**RE: National Construction Code (NCC) 2022 Volume One  
Amendment 2 Section J Part J4 Building Fabric Statement of  
Compliance**

**JOB NO.: 250138**

**SUBJECT PREMISE: Retail and Common Areas of 88 Waterloo Rd | 88 Waterloo Rd, Macquarie Park NSW 2113**

DOCUMENT No.: 250138  
 DOCUMENT TITLE: 88 Waterloo Rd - Building Fabric Requirement

1 DA2009 - LEVEL 1 1:200

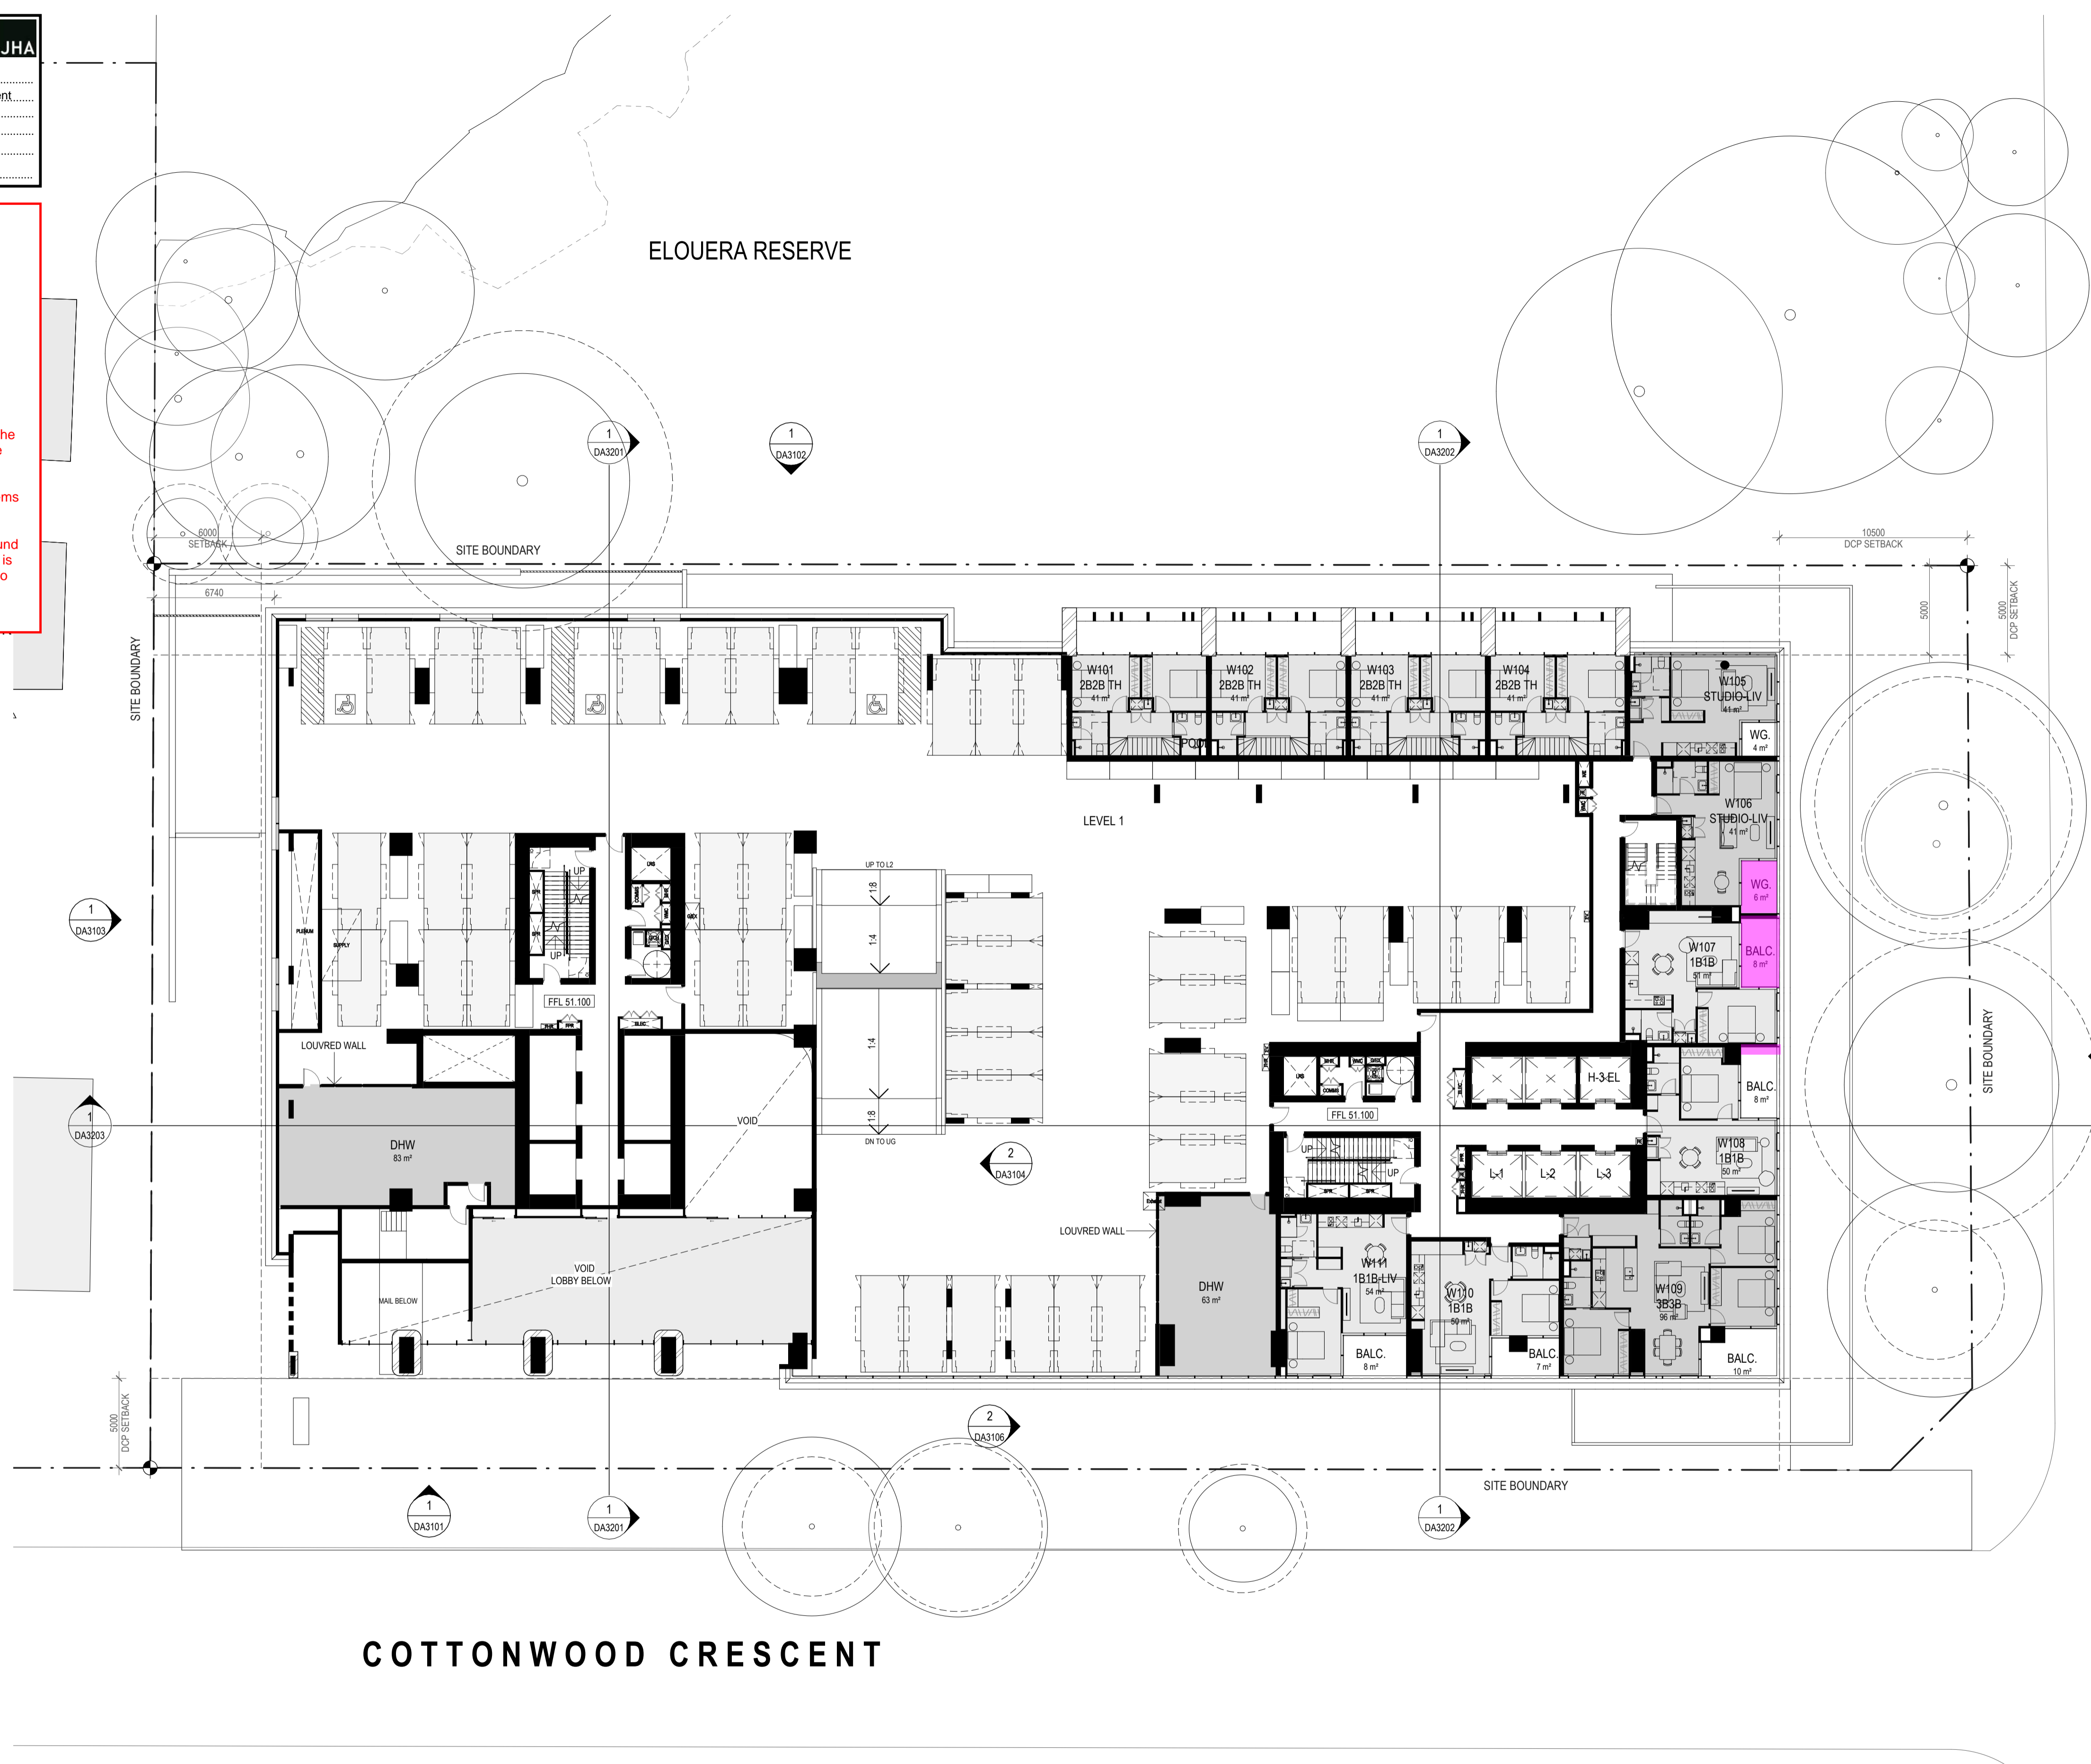
- ROOF/CEILING ENVELOPE: TOTAL R3.7 (DOWNWARD, SOLAR ABSORPTANCE NO MORE THAN 0.45)
- ENVELOPE FLOORS (SUSPENDED): TOTAL R2.0 (DOWNWARD)
- ENVELOPE FLOORS (SLAB-ON-GROUND): TOTAL R2.0 (DOWNWARD)\*
- ENVELOPE WALLS: TOTAL R1.4

Note: The above construction are only to be applied to the non-glazed portions of the envelope; glazing must be installed as per the architectural layouts with its thermal performances pursuant to the respective glazing specifications stated in the Section J report (Total Systems U-Value, and Total Systems SHGC value).

1 DA2012 - LEVEL 4 1:200

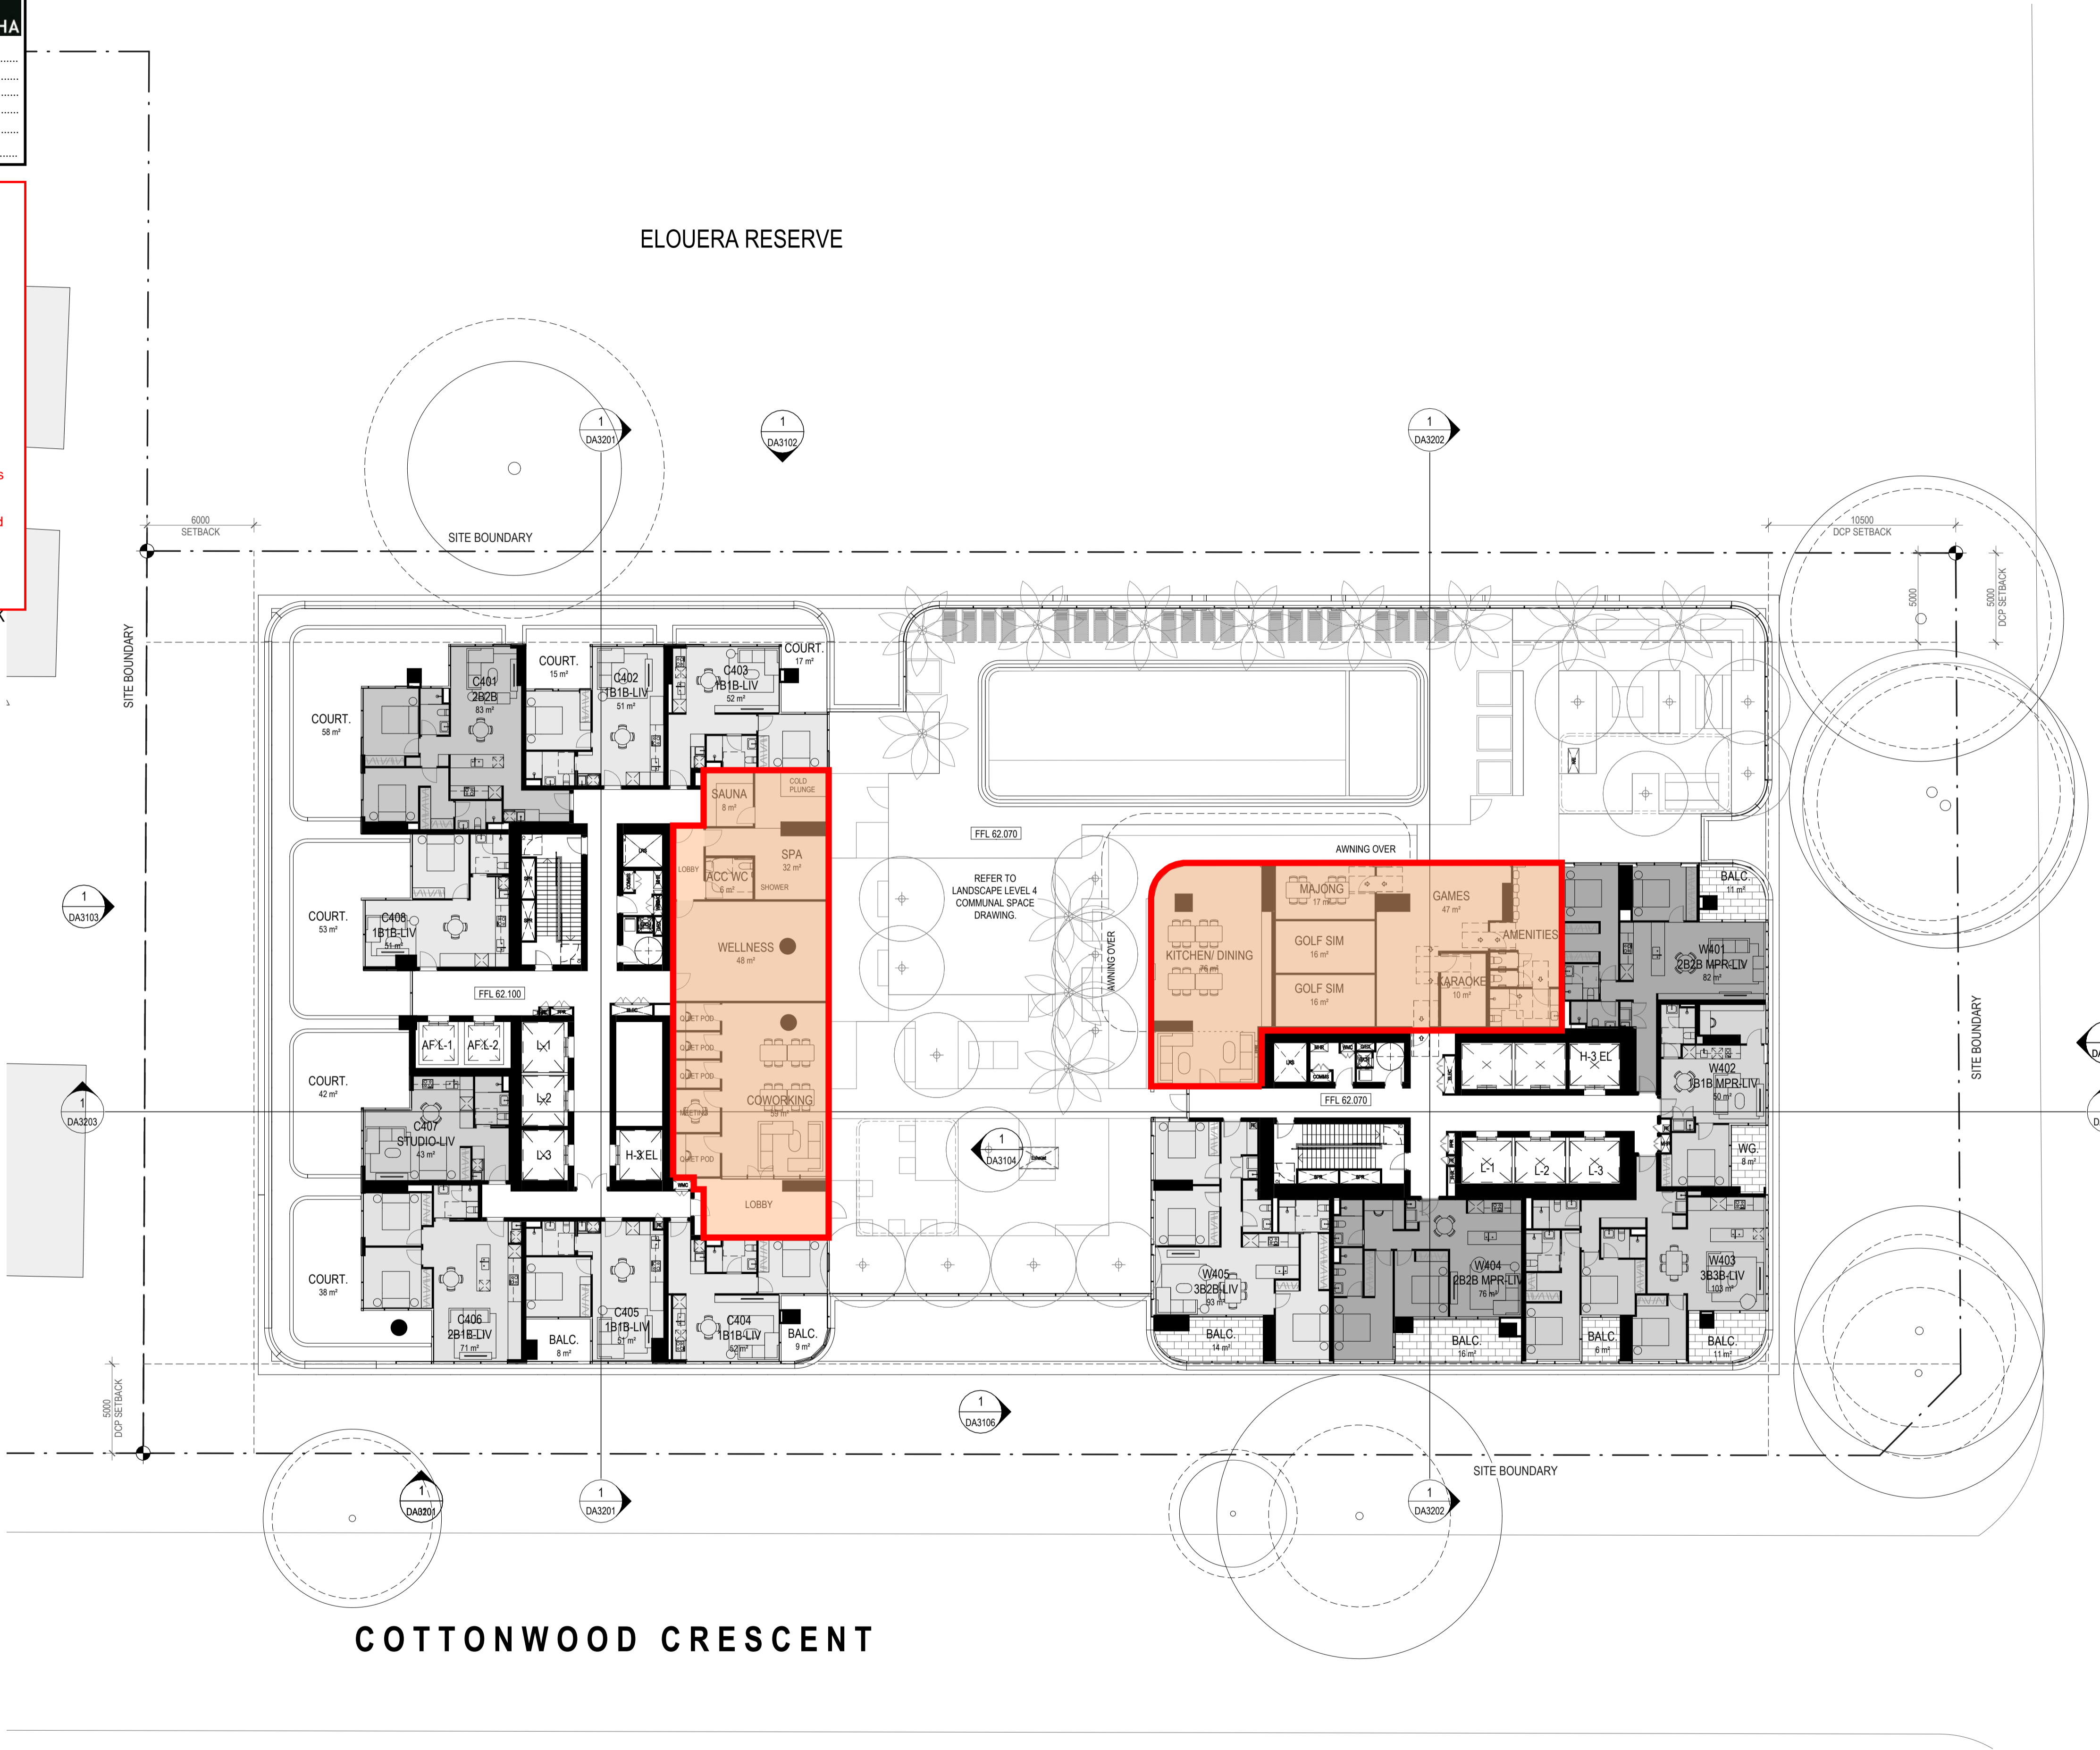
- ROOF/CEILING ENVELOPE: TOTAL R3.7 (DOWNWARD, SOLAR ABSORPTANCE NO MORE THAN 0.45)
- ENVELOPE FLOORS (SUSPENDED): TOTAL R2.0 (DOWNWARD)
- ENVELOPE FLOORS (SLAB-ON-GROUND): TOTAL R2.0 (DOWNWARD)\*
- ENVELOPE WALLS: TOTAL R1.4

Note: The above construction are only to be applied to the non-glazed portions of the envelope; glazing must be installed as per the architectural layouts with its thermal performances pursuant to the Section J report (Total Systems U-Value, and Total Systems SHGC value).
